STAFF REPORT: NOVEMBER 16, 2022 MEETING

APPLICATION NUMBER: 22-8101

ADDRESS: 47 WATSON (3100 WOODWARD)

SCOPE: ERECT OUTDOOR DINING STRUCTURE

Right: Applicant's site plan showing the interior circulation.

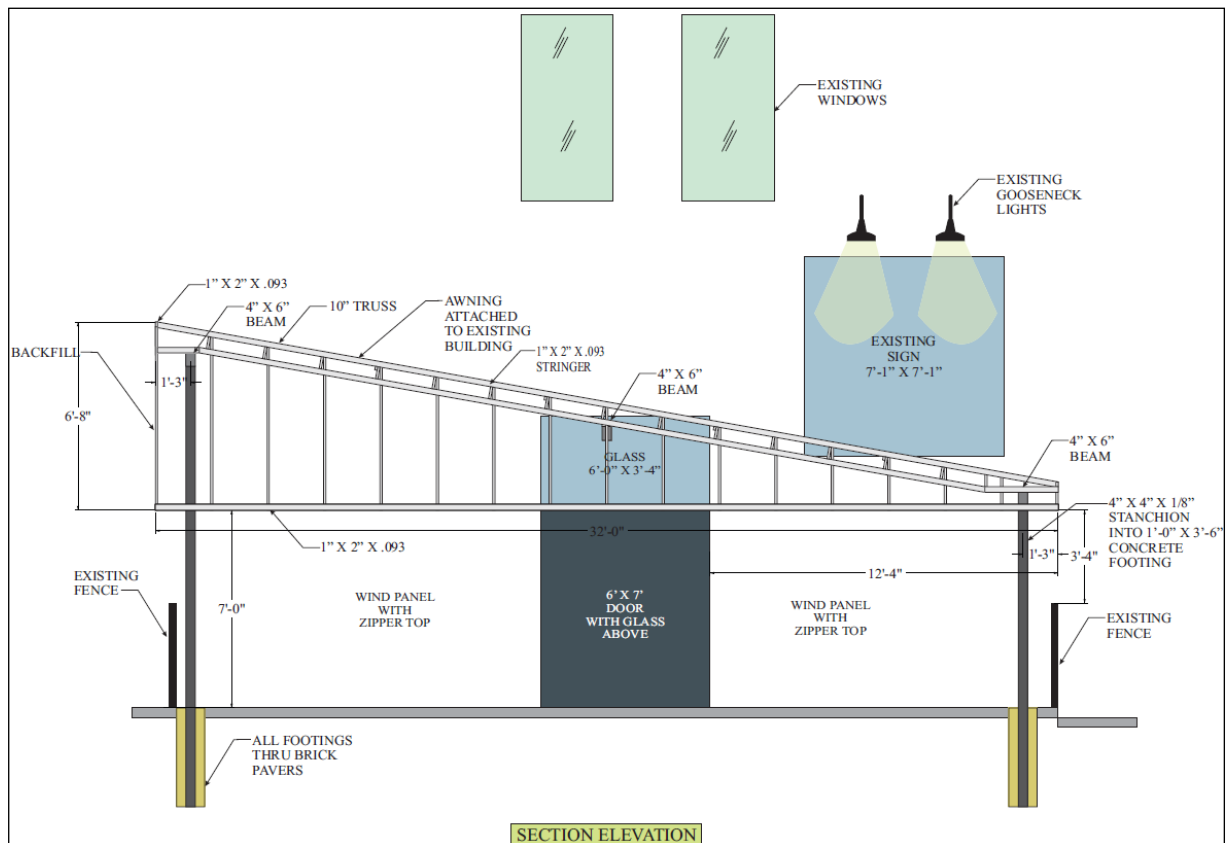
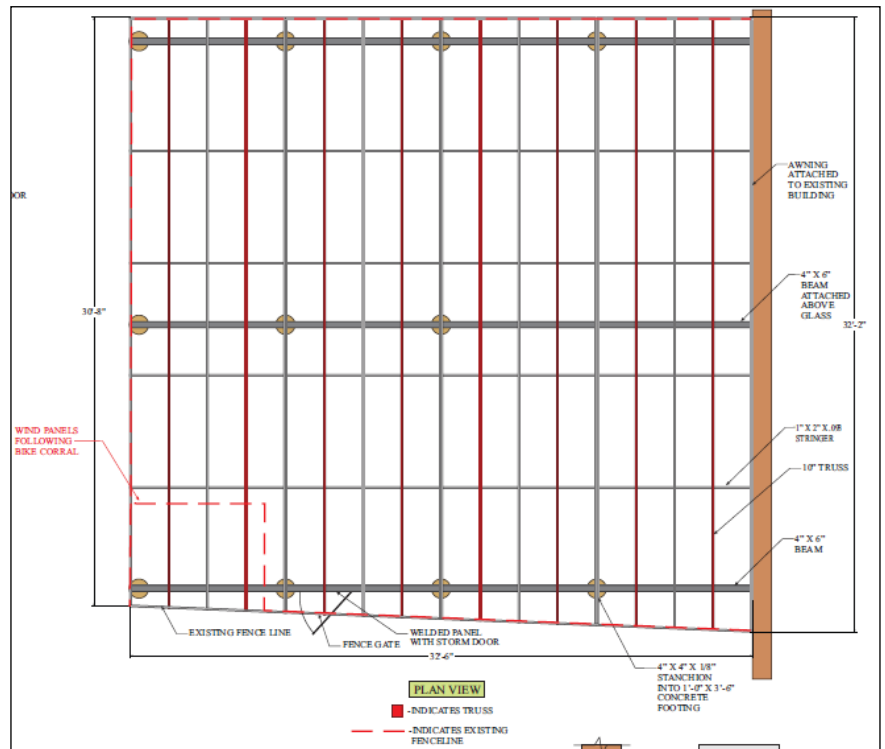
o The 2020 COVID Certificate of Appropriateness approved moveable seating. The submitted site plan shows “stadium seating” (details on method of construction and material/finish is needed) while existing conditions show an erected bar at the SE corner and a counter height table at the west (fence) elevation.

o Site plans (full and site plan with seating) shows trees in place, but they have been removed.

o Why would the front/west edge of the canopy be installed at an angle (as depicted on the plan view)?

o Submit expanded plan view to show all existing and proposed structural elements - including, but not limited to: existing fence posts, string light posts (or are these being removed?), 4”x 4” stanchions for canopy structure, and 2” x 2” stanchions for panel walls.

The actual site conditions are inconsistent with the site plan we submitted. Please see updated site plan showing the current type and number of seating.

Please see updated site plan to indicate the tree(s) that have been removed.

The front of the canopy follows the existing fence line, which angles back as it goes away from the building where the awning is mounted.

The existing tent and string lights attached to it will all be removed. The graphic rendering shows the location/placement of our proposed 4x4 stanchions in relation to the existing fence posts. There will be no 2x2 stanchions. Updated drawings will reflect this.

Applicant documents.

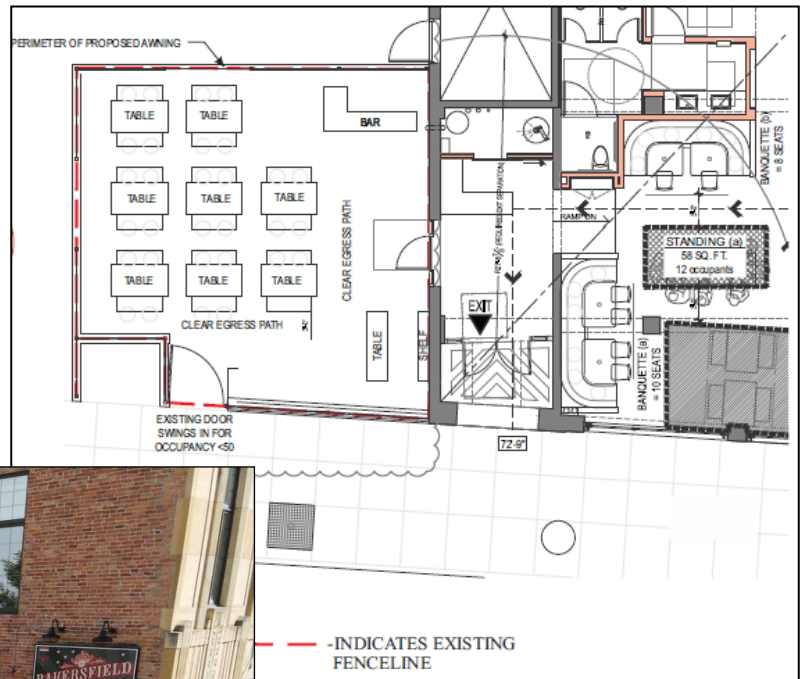
- The structure is highly visible due to its location at a primary elevation along a major thoroughfare. It abuts the sidewalk and is in line with 3100 Woodward, which houses the restaurant for which this outdoor dining area is designated.

- It is common for a building within the commercial streetscape to have a varied color palette between the building's veneer, applied trim, and storefront framing. The proposed structure's black fabric walls with small vinyl openings (that will likely be less transparent than glass) and sloping roof, will create a dark massing that is out of proportion with the surrounding buildings.

- It is staff's opinion, the structure doesn't read as a building, nor does it read as an awning. It doesn't offer any architectural detail befitting a Woodward Avenue streetscape location.
